CASE#: SPC-2010-0061C
 ADDRESS: 202 S Lamar Blvd
 GRID: H22
 MANAGER: NIKKI HOELTER

SUBJECT: ZACH New Theatre

The ZACH Theatre project team respectfully submits the following responses to the May 7, 2010 Design Commission recommendation letter.

ZACH THEATRE LANDSCAPE PLAN
Zachary Scott Theatre Center
Austin, Texas

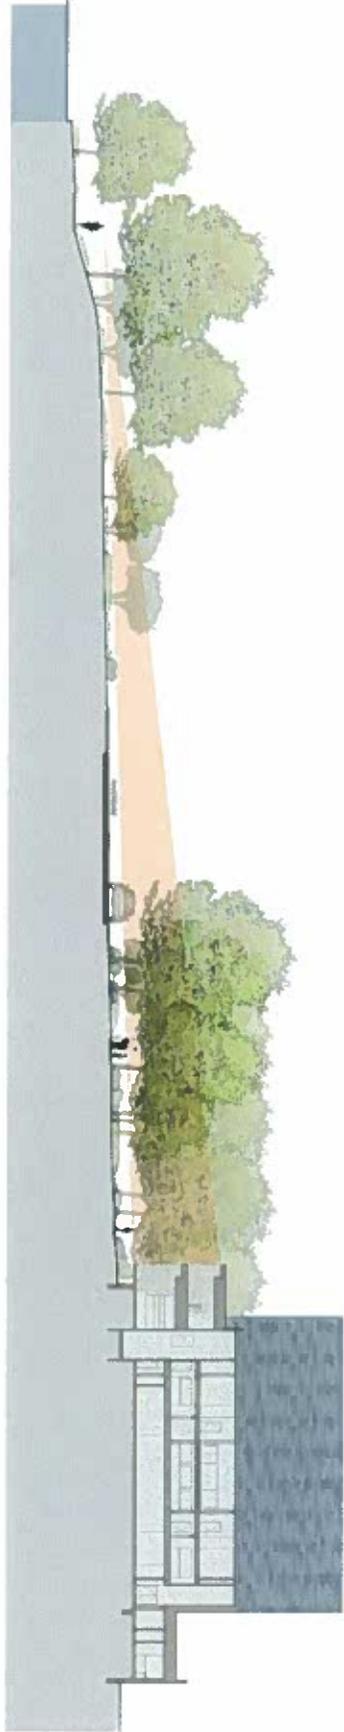
- *"The Commission recommends that the project build to the property line along Lamar if it can accommodate the double row of trees shown in the plan."*

- *"The Commission recommends that the orientation of the building along Lamar be aligned with the angle of the street."*

- *"The Commission also encourages that the building be moved northward to the building set back line to allow for more landscape buffering between the existing parking lot to the south and the proposed loading drive."*

The project design team is proposing a double row of Monterrey Oaks along the Lamar Boulevard sidewalk on the east edge of the property to enhance the pedestrian experience. See Exhibits A, B and H. The second row of trees is entirely within the property line. The theatre is positioned as closely as possible against the second row of trees. Moving the theatre closer to the property line would require the removal of the second row of trees.

The alignment allows for space along the south side of the building for additional landscaping of the staff and actor pedestrian paths and loading area. See Exhibits A and H.

The location of the proposed service drive is not dependent on building location, but rather the decision by the project team to protect the 21" Live Oak tree (Tree #576). The minimum 12' wide drive must pass to the south of the tree. To move the drive toward the tree to allow for more landscape buffering would have a greater impact the critical root zone and overhead limbs and could require removal of the 21" Oak Tree. See Exhibit A.

VIEW FROM LAMAR LOOKING NORTH
ANDERSSON-SCHWABE ARCHITECTS © 2009

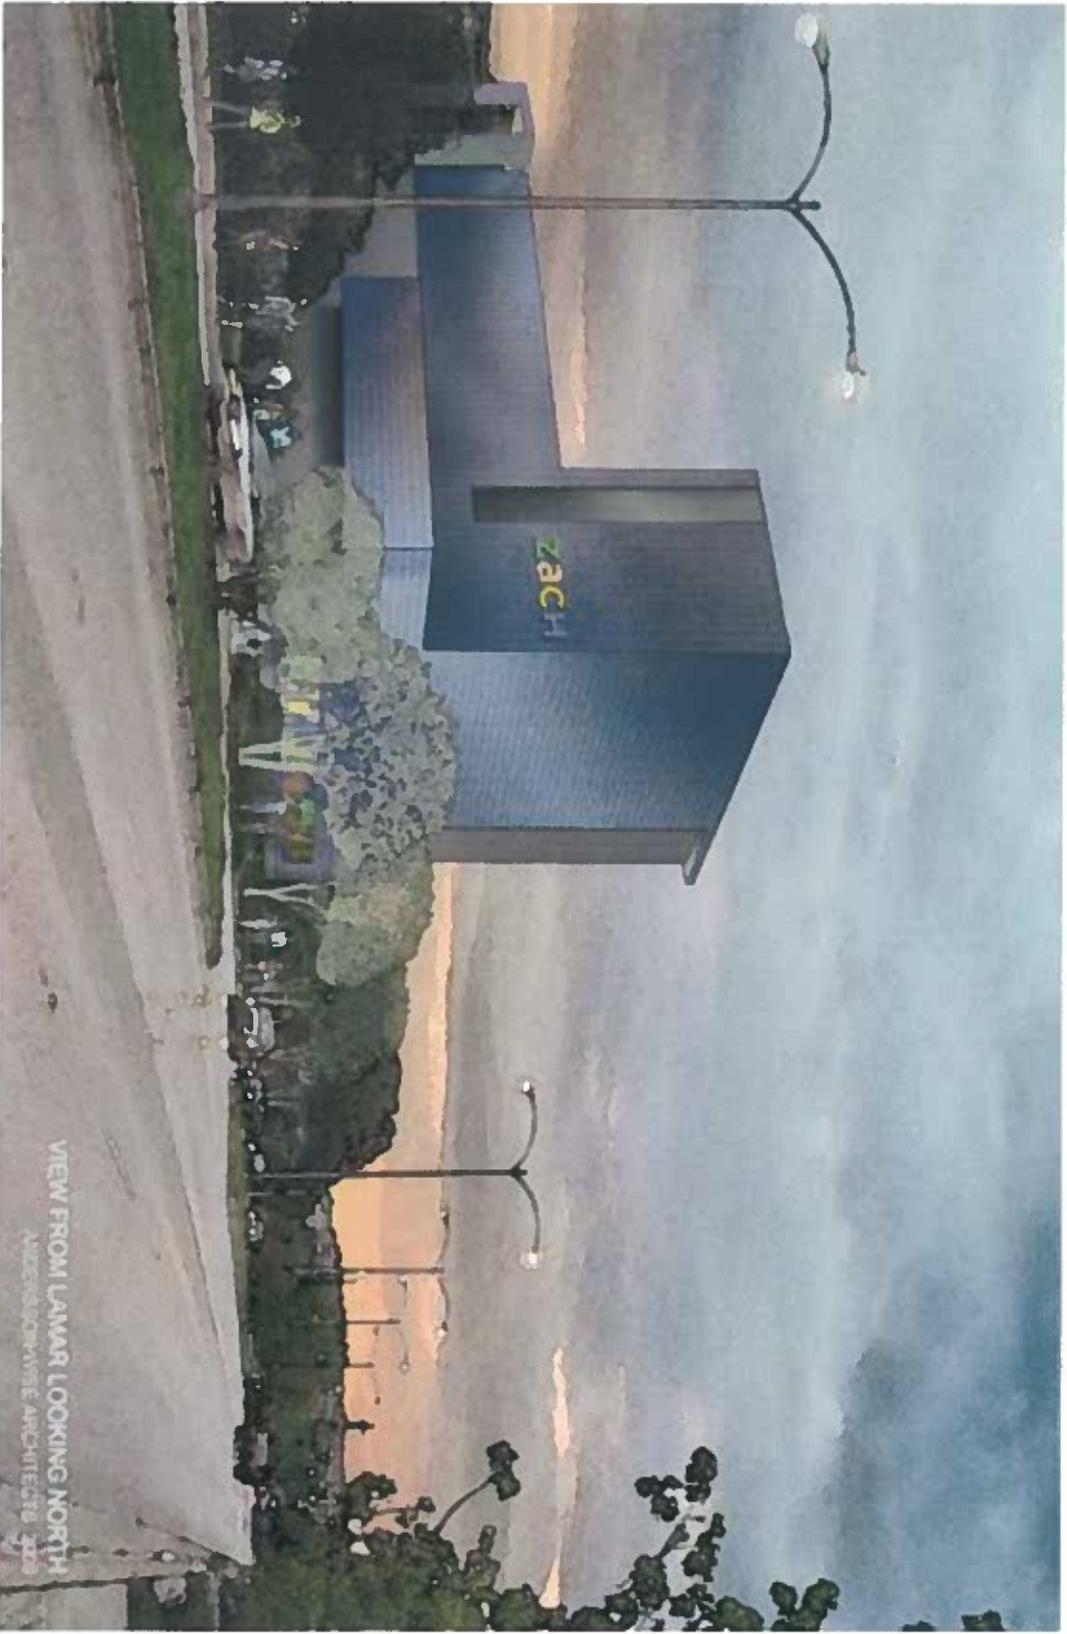
- *"The Commission recommends that the internal orientation of the theater building address Lamar, or address both Lamar and the internal campus together rather than the campus alone."*

The mass of the tower on the south, east and north sides is broken up by changes in material and facade recesses. See Exhibits D, F and G.
